UNITED STATES PATENT AND TRADEMARK OFFICE

APPLICATION NO.	FILING DATE	FIRST NAMED INVENTOR	ATTORNEY DOCKET NO.	CONFIRMATION NO.
10/711,144	08/27/2004	Douglas D. Coolbaugh	BUR920040107US1	5143
45601 7590 10/15/2007 SCULLY, SCOTT, MURPHY & PRESSER, P.C. 400 GARDEN CITY PLAZA Suite 300 GARDEN CITY, NY 11530			EXAMINER NGUYEN, KHIEM D	
			ART UNIT 2823	PAPER NUMBER
			MAIL DATE 10/15/2007	DELIVERY MODE PAPER

Office Action Summary

DETAILED ACTION

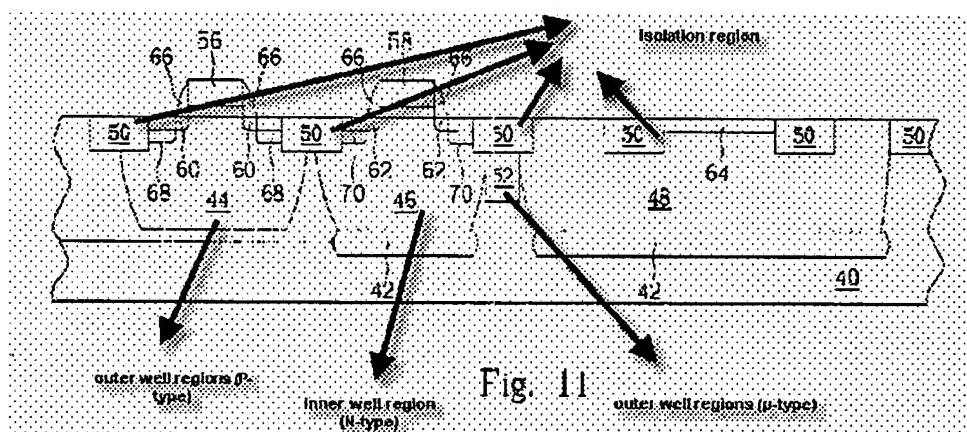
Applicants contend that the reference Gau (U.S. Patent 6,949,440), herein known as Gau, fails to disclose, inter alia, "a well region located in the upper region of the substrate, wherein the well region includes outer well regions of the second conductivity type and an inner well region of the first conductivity type, each well of alternating conductivity type of the well region is separated at an upper surface by an isolation region and each outer well region has an upper surface which includes a source/drain regions".

In response to Applicants' contention that Gau does not teach or suggest a well region located in the upper region of the substrate, wherein the well region includes outer well regions of the second conductivity type and an inner well region of the first conductivity type, each well of alternating conductivity type of the well region is separated at an upper surface by an isolation region, Examiner respectfully disagrees.

Applicants' attention is respectfully directed to (col. 4, lines 11-65 and FIGS. 8-10, for example) where Gau discloses a varactor structure comprising: a well region

located in the upper region of the substrate 40, wherein the well includes outer well regions 44 and 52 of the second conductivity type (P-type) (see col. 4, lines 27-40) and an inner well region 46 of the first conductivity type (N-type) (col. 4, lines 41-42), each well of alternating conductivity type (P-N-P) of the well region is separated at an upper surface by an isolation region 50 (see col. 4, lines 31-40 and FIG. 11, as shown below, for example).

For this reason, Examiner holds the rejection proper.
